Item ID: D206-667-107BL Accept ***N900040100*** Setup Start ***NS1***
Revision ID: Stop ***NS2***
Item Name: Fwd Crosstube - Mid Height 206L / L1 / L3 / L4, Blue
Start Date: 6/14/2017 Start Qty: 1.00 ***1*** Cust Item ID:
Required Date: 6/29/2017 Req'd Qty: 1.00 ***1*** Customer:
Reference:

DART AEROSPACE LTD		Work Order:	162182
Description: Crosstube Mid Fwd (206L)		Part Number:	D206-667-107
Inspection Dwg: D206-667-147	Rev: A	Page 1 of 1

DART AEROSPACE LTD	
HAWKESBURY, ONTARIO, CANADA	
DRAWING NO.	REV. A
D206-667-147	SHEET 1 OF 4
TITLE	SCALE
CROSSTUBE ASS'Y (206L MID FWD)	NTS

DRAWING NO.	D206-667-147	TITLE	REV. A	DART AEROSPACE LTD ENGINEERING ORDER	D.E.O. NO.	D206-667-147-A-1	SHEET NO.	SHEET 1 OF 1	SCALE	NTS
DRAWN	q	CHECKED	ADS	MFG. APPR.	APPROVED	MD	DE APPR.			
DATE	11.07.15	DATE	11.07.20	DATE	11.07.21	DATE	11.07.21	DATE	11.07.21

D206-667-147
ASSEMBLY DETAIL
(VIEW LOOKING FWD)

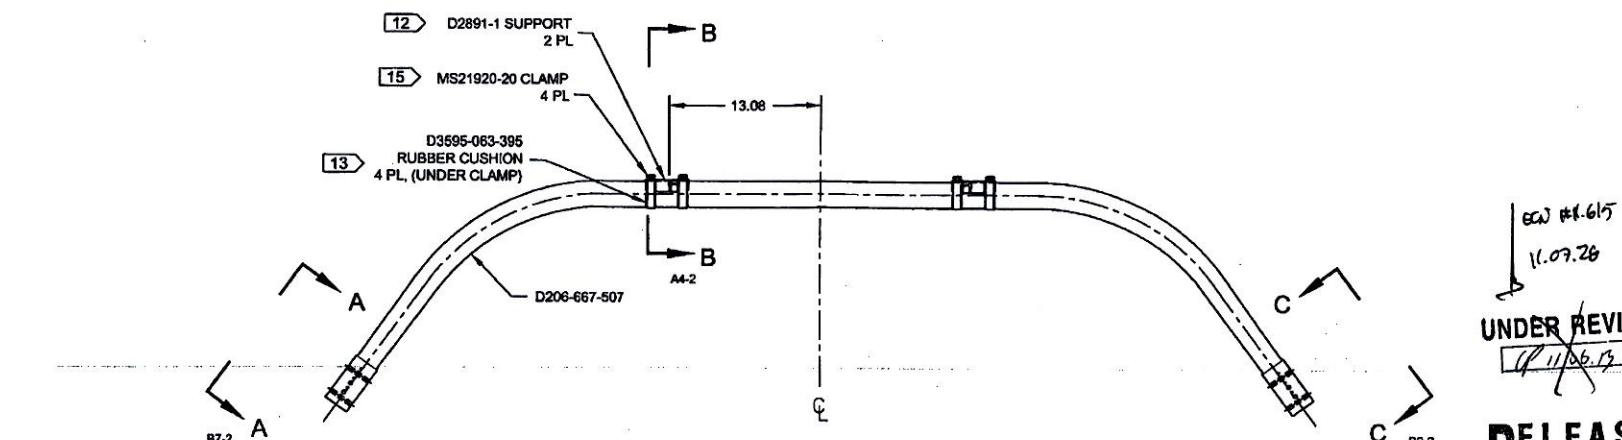
PURPOSE:
REPLACE MAGNOBOND WITH PROSEAL.

NOTE 12 & 15, SHEET 1 IS AMENDED AS FOLLOWS:

12) INSTALL D2891-1 SUPPORT USING 0.03" TO 0.06" THICK LAYER OF MAGNOBOND 6398 PER QSI 015. LET CURE FOR 12 HOURS AFTER INSTALLATION AND PRIOR TO PACKAGING.

15) TORQUE CLAMPS 80 TO 100 IN.-LB. ENSURE AT LEAST 1.5 THREADS SHOWING IN SAFETY AND THAT NUT HAS NOT BOTTOMED-OUT AFTER TORQUING.

12) TO INSTALL D2891-1 SUPPORT: ABRASE MATING SURFACE OF SUPPORT AND CROSSTUBE WITH 180-GRIT SANDPAPER AND REMOVE RESIDUE WITH MEK (OR EQUIVALENT). APPLY A 0.04" TO 0.07" THICK LAYER OF PROSEAL 890 CLASS B-2 (OR AMS-S-8802 CLASS B-2) SEALANT TO MATING SURFACE OF SUPPORT.

15) TORQUE CLAMPS 80 TO 100 IN.-LB. ENSURE AT LEAST 1.5 THREADS SHOWING IN SAFETY AND THAT NUT HAS NOT BOTTOMED-OUT AFTER TORQUING. PRIOR TO PACKAGING, RE-CHECK TORQUE ON CLAMPS AFTER PROSEAL 890 SEALANT HAS CURED FOR 72 HOURS.

DETAIL P
BONDING STRAP INSTALLATION 2 PL

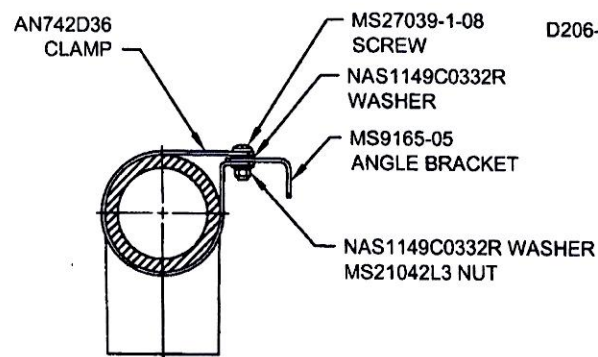
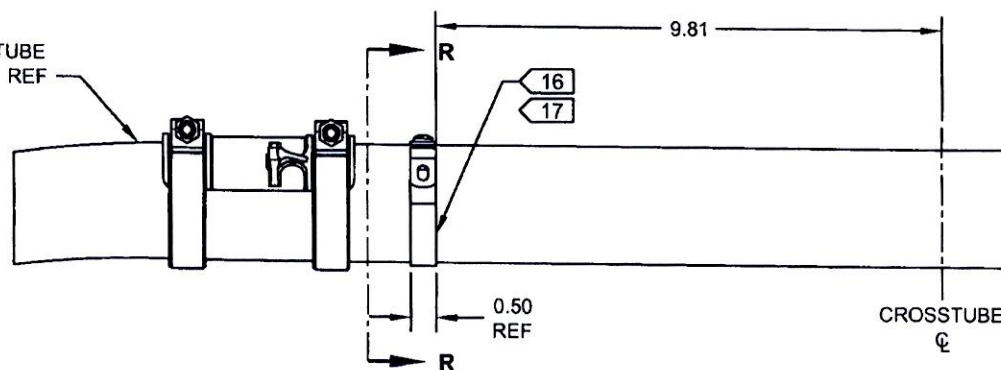
ADD ELECTRICAL GROUNDING STRAP

ITEM	QTY	PART NUMBER	DESCRIPTION
1	X	D206-667-147	CROSSTUBE ASSEMBLY (206L MID FWD)
10	2	AN742D36	CLAMP
11	2	MS9165-05	ANGLE BRACKET
12	2	MS21042L3	NUT (OR MS21042-3)
13	2	MS27039-1-08	SCREW
14	4	NAS1149C0332R	WASHER (OR AN960C10L)
